Access Compliance Report

Public Rights-of-Way

(Pedestrian Signals)

Intersection ID: N/A	Main Street:	Cross Street: N/A	Location: N/A
ADA ID: 52155F9C24C7	Signal Type: Two Push Buttons-Non APS	Overall Compliance: No	Severity Score: BTN 1:N/A BTN 2: N/A No BTN: N/A
Codes/Mitigation Info/Possible Solution		Field Measurements/Component Compliance

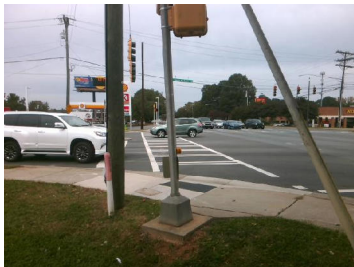
PROW/ADA: TMUTCD 4e.08, R406.2, R404.7.3, R404.2, R404.3

Compliance	Description	Data	Compliance	Description	Data
	Button Count	Button2	N/A	Distant to Additional Button (in)	N/A
	Additional Button Present?	No		Additional Button ID	N/A
N/A	Signal Buttons Required?	N/A	N/A	Additional Ped Posts Required	N/A
	How Many Ped Street Xings?	2		Located In An Island/Median?	No
N/A	B 1 Sign Present?	Yes	N/A	B 2 Sign Present?	Yes
Yes	B 1 Sign Purpose?	Yes	Yes	B 2 Sign Purpose?	Yes
Yes	B 1 Sign Lettering & Contrast?	Yes	Yes	B 2 Sign Lettering & Contrast?	Yes
Yes	B 1 Parallel To XWalk?	Yes	Yes	B 2 Parallel To XWalk?	Yes
Yes	B 1 PAR to Button?	Yes	Yes	B 2 PAR to Button?	Yes
Yes	B 1 PAR to XWalk?	Yes	Yes	B 2 PAR to XWalk?	Yes
Yes	B 1 Clear Floor Space?	Yes	Yes	B 2 Clear Floor Space?	Yes
N/A	B 1 FWD Approach?	Yes	N/A	B 2 FWD Approach?	Yes
N/A	B 1 FWD Approach Constrained?	No	N/A	B 2 FWD Approach Constrained?	No
No	B 1 FWD Approach Reach (in)	16.0	No	B 2 FWD Approach Reach (in)	16.0

N/A	B 1 FWD Approach Width (in)	N/A	N/A	B 2 FWD Approach Width (in)	N/A
N/A	B 1 FWD Approach Obstruction?	Yes	N/A	B 2 FWD Approach Obstruction?	Yes
N/A	B 1 FWD Approach Obstruction Dist (in)	10.0	N/A	B 2 FWD Approach ObstructionDist (in)	10.0
N/A	B 1 PARA Approach?	Yes	N/A	B 2 PARA Approach?	Yes
N/A	B 1 PARA Approach Constrained?	No	N/A	B 2 PARA Approach Constrained?	No
No	B 1 PARA Approach Reach (in)	11.0	Yes	B 2 PARA Approach Reach (in)	10.0
N/A	B 1 PARA Approach Width (in)	N/A	N/A	B 2 PARA Approach Width (in)	N/A
N/A	B 1 PARA Approach Obstruction?	Yes	N/A	B 2 PARA Approach Obstruction?	Yes
N/A	B 1 PARA Approach Obstruction Dist (in)	8.0	N/A	B 2 PARA Approach ObstructionDist (in)	8.0
Yes	B 1 Clear Floor Space Slope (%)	9.7	No	B 2 Clear Floor Space Slope (%)	9.4
Yes	B 1 Clear Floor Space XSlope (%)	0.8	Yes	B 2 Clear Floor Space XSlope (%)	0.3
N/A	B 1 PAR Slope (%)	9.7	N/A	B 2 PAR Slope (%)	3.0
Yes	B 1 Height (in)	37.5	Yes	B 2 Height (in)	38.5

Yes	B 1 Clear Xing Direction?	ClearlyMarked	Yes	B 2 Clear Xing Direction?	ClearlyMarked
	B 1 Crossing Direction	To NE		B 2 Crossing Direction	To NW
Yes	B 1 DistanceTo XWalk (in)	0.0	Yes	B 2 DistanceTo XWalk (in)	0.0
No	B 1 DistanceTo Curb (in)	94.0	No	B 2 DistanceTo Curb (in)	101.0
Yes	B 1 Diameter (in)	2.0	Yes	B 2 Diameter (in)	2.0

Possible Solutions: Replace Signal Push Button With APS Button on New Post. Remove & Relocate Sign.
